INTERNAL MEMORANDUM

SUBJECT: P/26/0071 | Replacement of two existing windows with new doors and removal of an additional existing window. Replacement of the existing external fence with a new 2.4m-high fence and provision of hardstanding | Troedyrhiw Primary School-Juniors Building No. 2 Archer Street Troedyrhiw Merthyr Tydfil CF48 4JQ

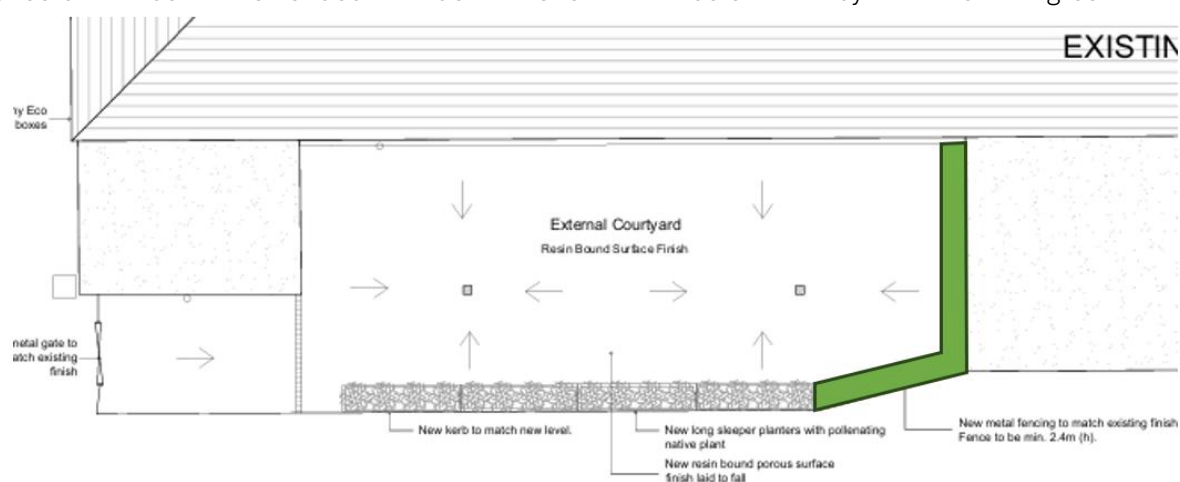
- The bat and bird boxes must not be illuminated. There will be no increased onsite lighting.
- The scheme will remove areas of grass and proposes the introduction of linear sleeper planters. These should be extended as shown below by the green polygon:
